2. Project descriptions and justification

2.2 Proposed modifications and justifications — summary

This modification EA has been prepared to support six modifications of the approved Camellia and Rosehill Recycled Water project (approval No. 07_0121). This section of the EA describes and justifies each of the proposed modifications and discusses the alternatives considered during the development of the modifications.

2.3 Modification 1 — Fairfield Park to Normanby Street recycled water pipeline route modification

Figure 2-2 Distribution system overview including modification

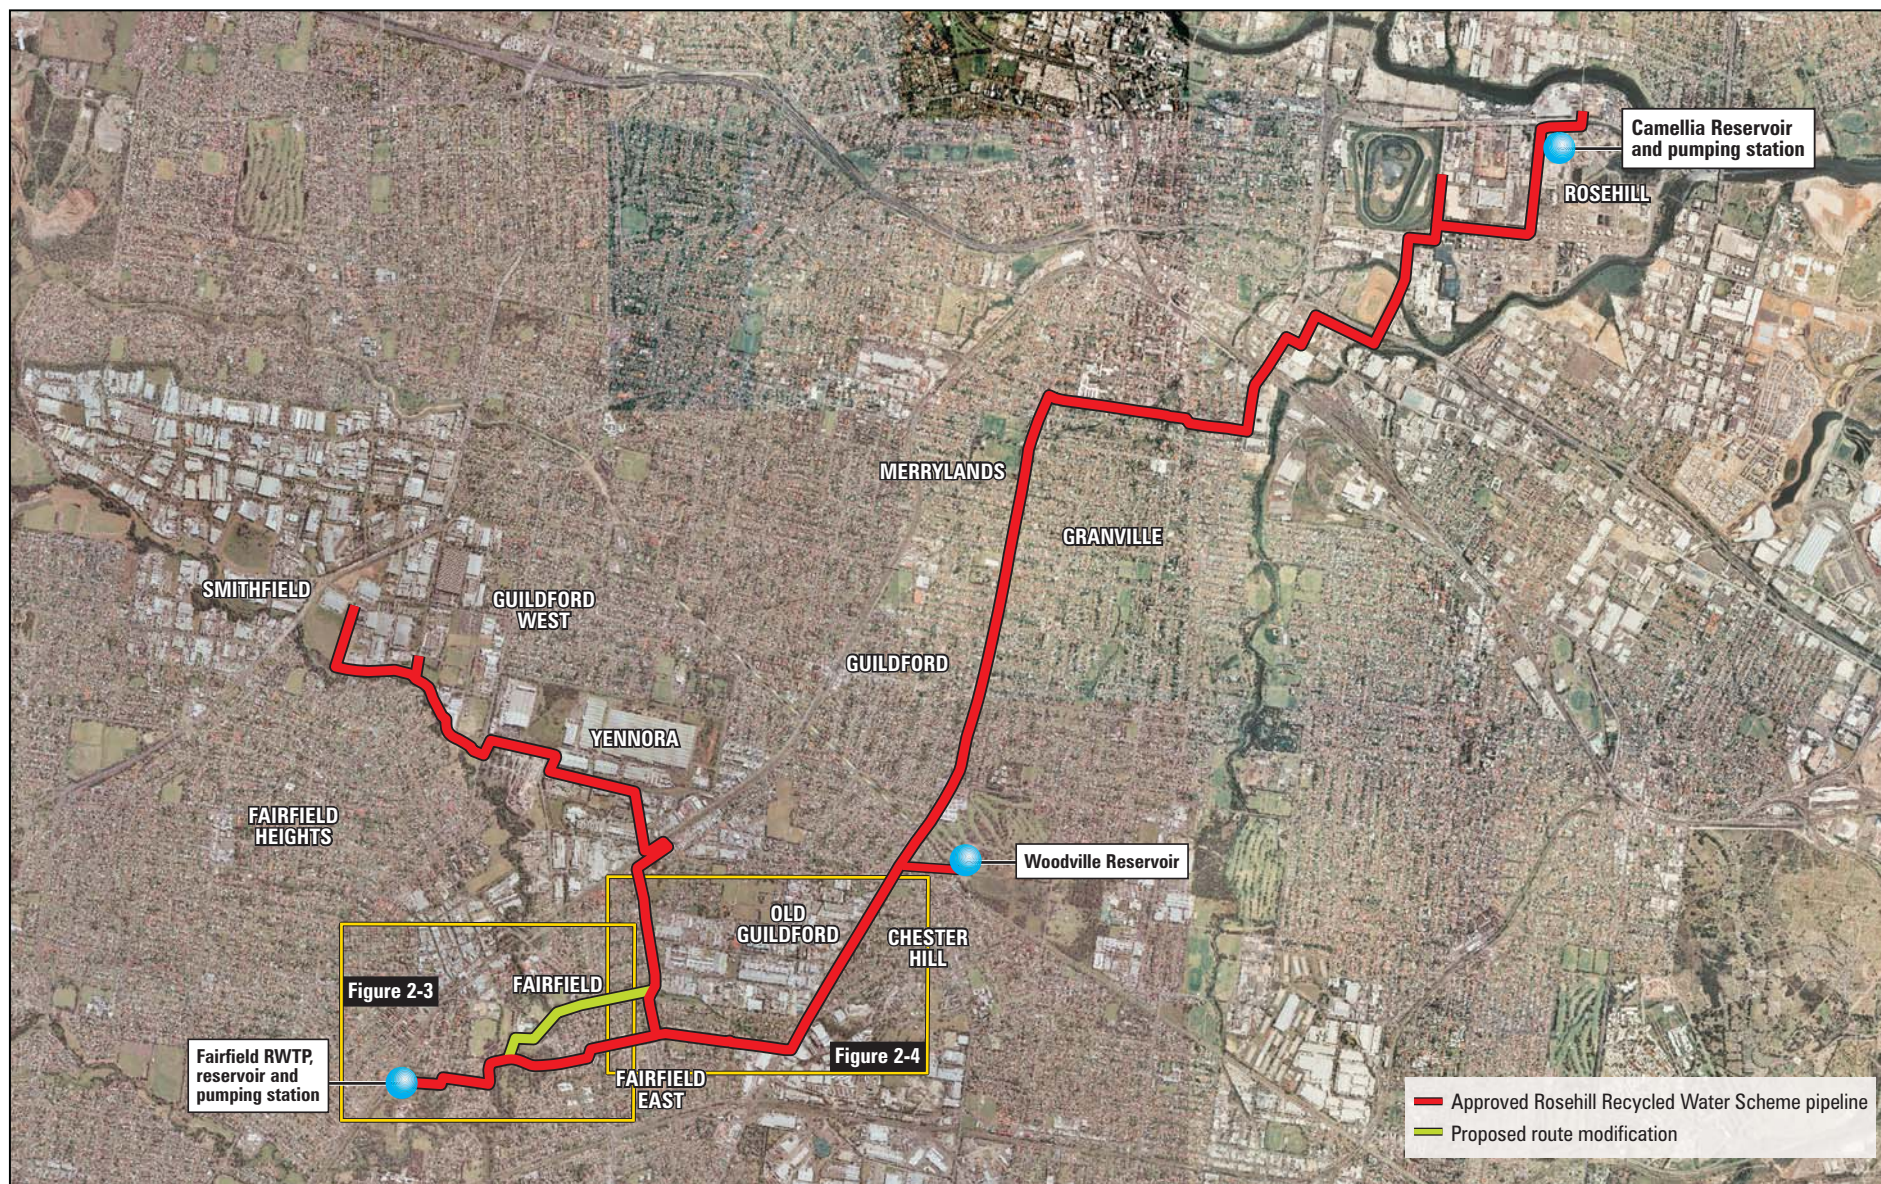
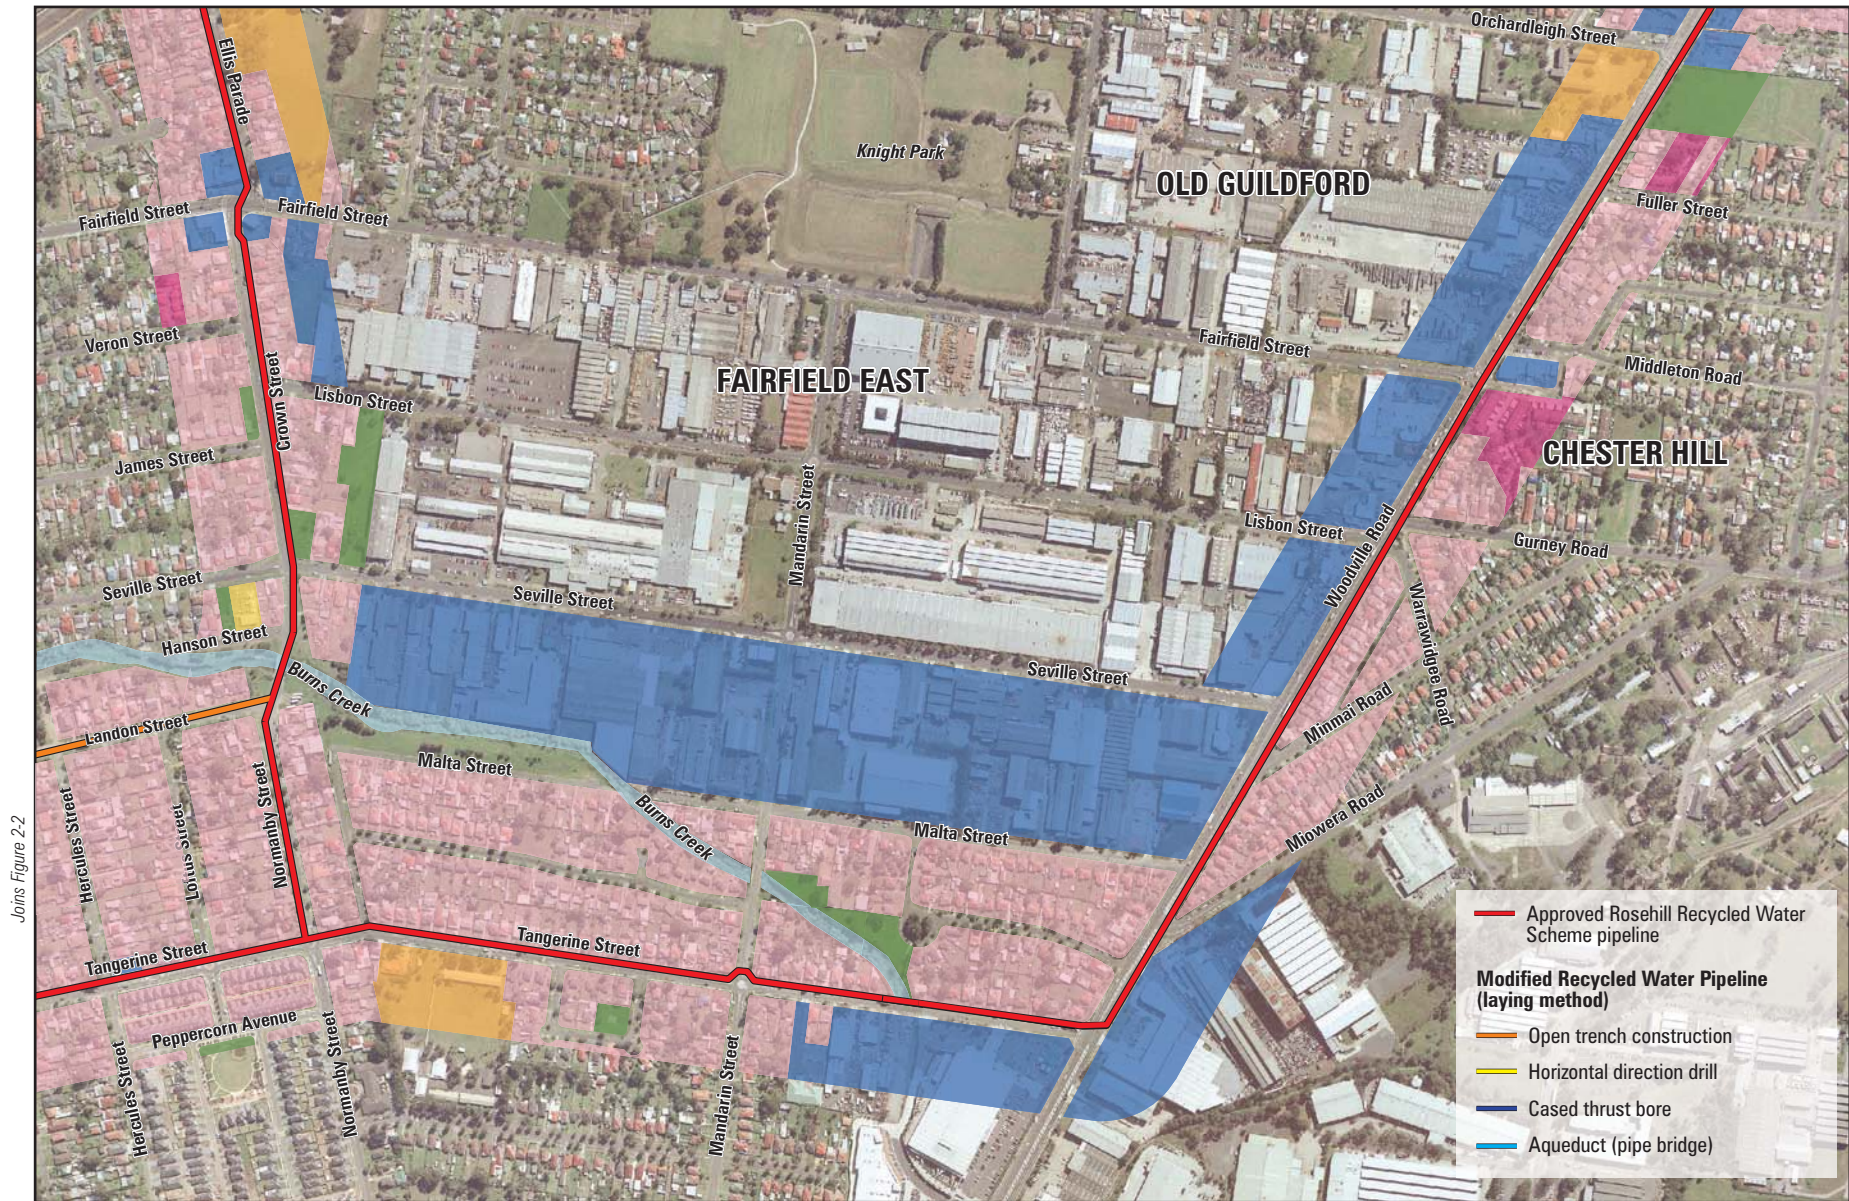
The modification to the pipeline route would involve the deviation of approximately 1.16 km of the approved pipeline between Fairfield Park and Normanby Street (refer Figure 2-2). The pipeline would vary in diameter between approximately 400 and 450 mm within the length of the modification. This is consistent with the approved pipeline.

The proposed realignment of the approved pipeline would also include a creek crossing, as shown in Figure 2-3. The route of the modified pipeline alignment is discussed below.

Trenching of the modified pipeline route would start in Fairfield Park, generally following the existing internal roadways and disturbed tracks behind the Fairfield Leisure Centre. The pipeline would then use a trenchless construction technique (thrust boring) to cross under Vine Street to Makepeace Oval. Open trenching would then continue following the access track around Makepeace Oval, crossing under Prospect Creek and Burns Creek to Landon Street. Another trenchless construction technique would be used to cross this sensitive area (horizontal directional drilling – HDD). This section of the modified pipeline route would be approximately 640 m long.

From Landon Street, open trenching would continue in an easterly direction before crossing connecting with the approved pipe at Normanby Street. Trenching along this section of the alignment would generally occur on the southern side of Landon Street. This section of the modified pipeline route would be approximately 520 m long.

Figure 2-6 Revised transformer location within the Fairfield RWTP

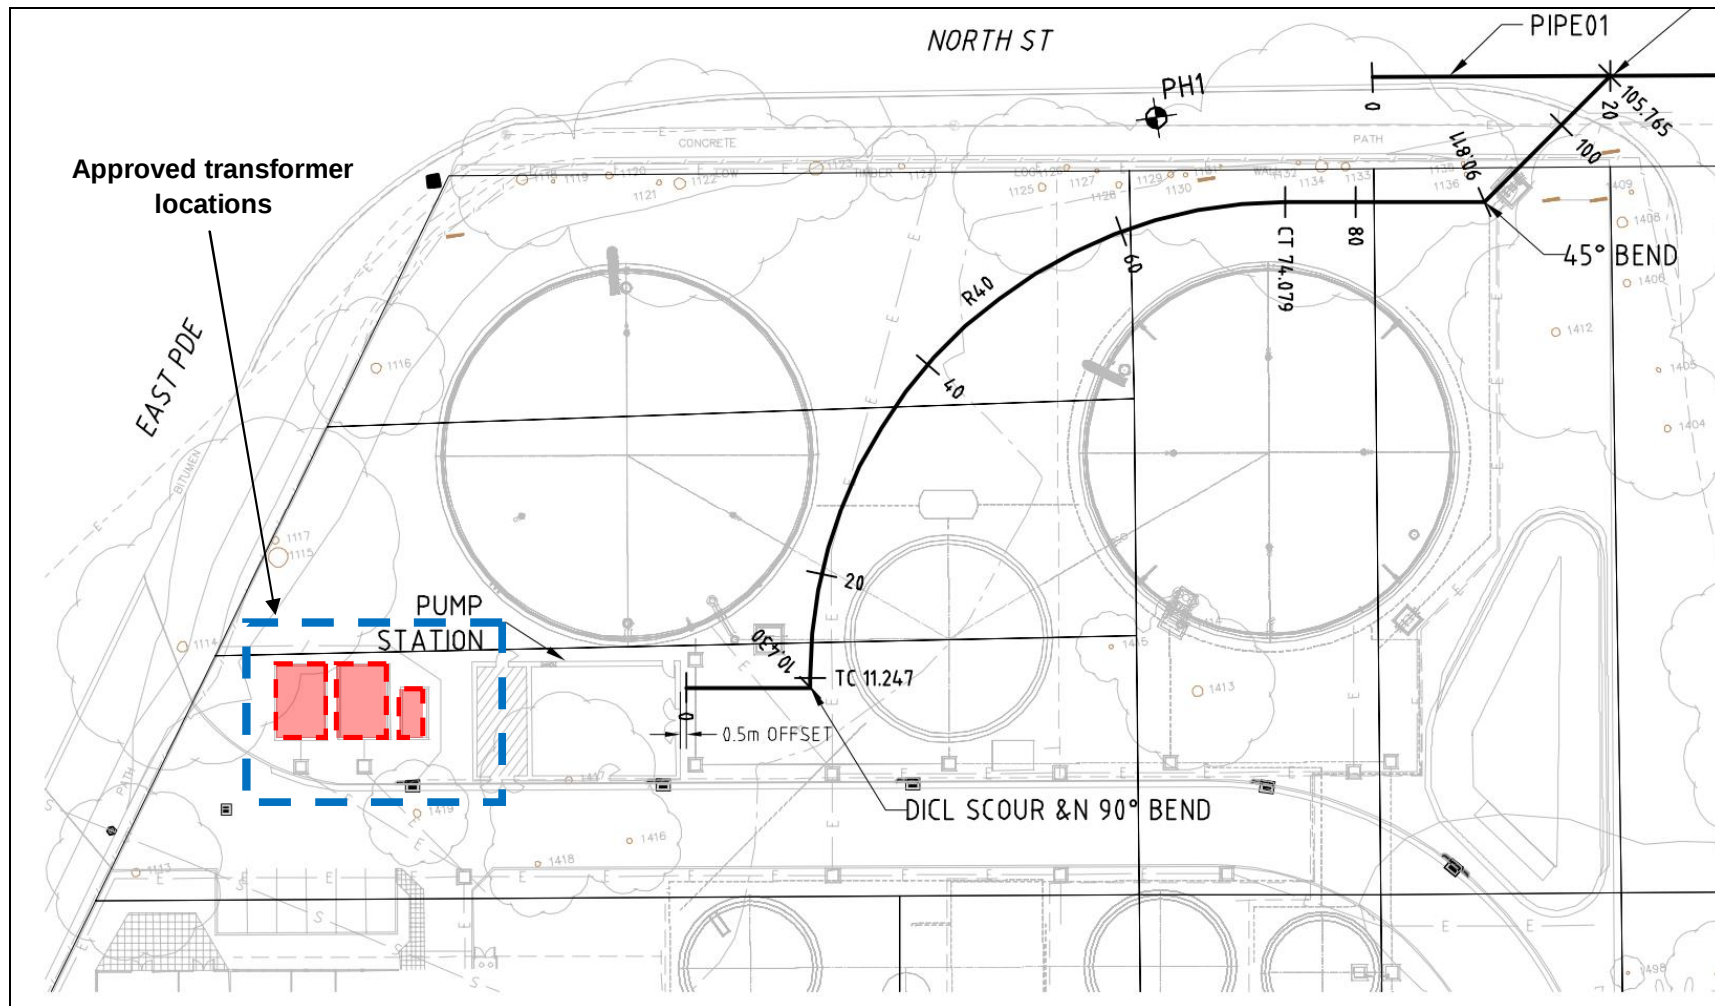
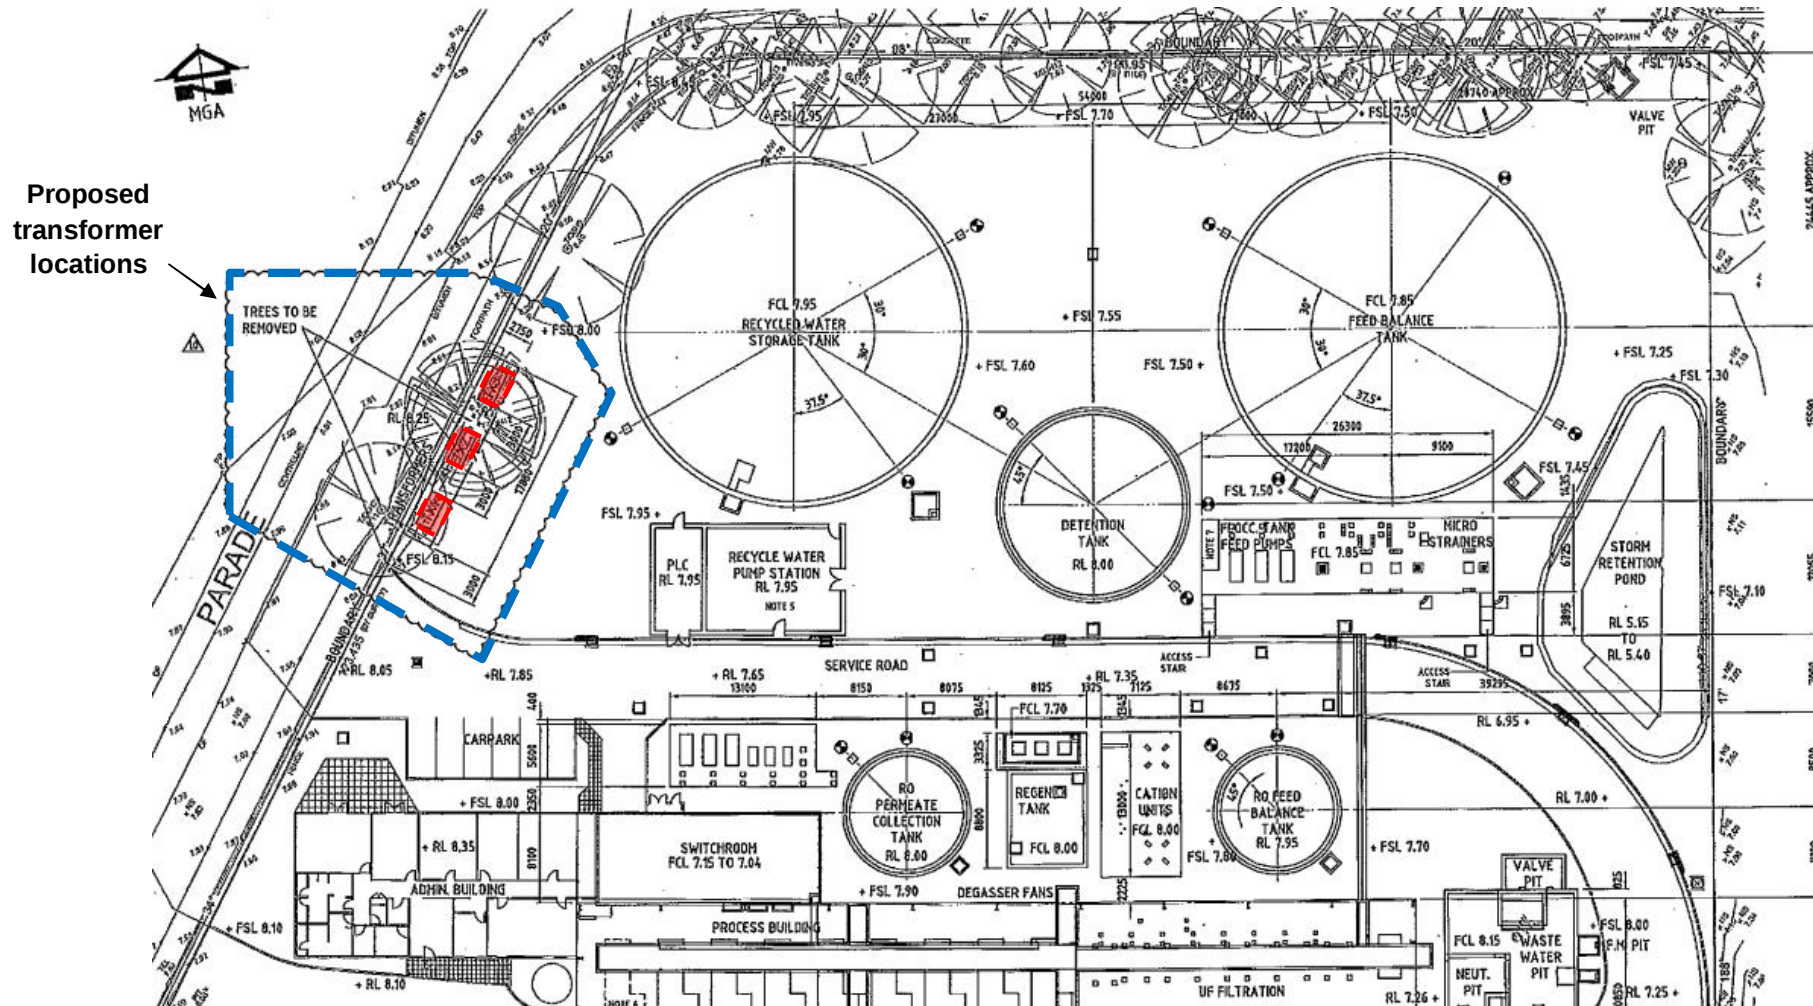
The approved Project provided for the construction of 2 x 1,500 kVA and 1 x 500 kVA transformers at the Fairfield RWTP located at the corner of North Street and East Parade, Fairfield. This combination of transformers was included in operational noise modelling and compliance assessment in the PPR (March 2009) and their location was approved near the western boundary of the site off East Parade (refer Figure 2-5).

This modification proposes to construct 3 x 1,500 kVA transformers at this site by replacing the approved 1 x 500 kVA transformer with an additional 1,500 kVA transformer. This will provide additional power redundancy for the operation of the pumping station.

The location of the transformers will also be slightly amended to reflect the needs of the power supply service, Salem Engineering Power Services. The transformers are located near the East Parade boundary of the site (refer Figure 2-5); they will be relocated to an area closer to the boundary of the Fairfield RWTP along East Parade. Figure 2-6 shows the modified location of the transformers.

Salem Power Engineering Services recommended that 'the most suitable location to meet Integral Energy's additional requirements is along the front property boundary alongside the entrance gateway'. The proposed modification, therefore, includes the minor relocation of the bank of transformers within the site, however, they will remain along the western boundary of the site off East Parade (refer Photo 2-8 and Figure 2-6).
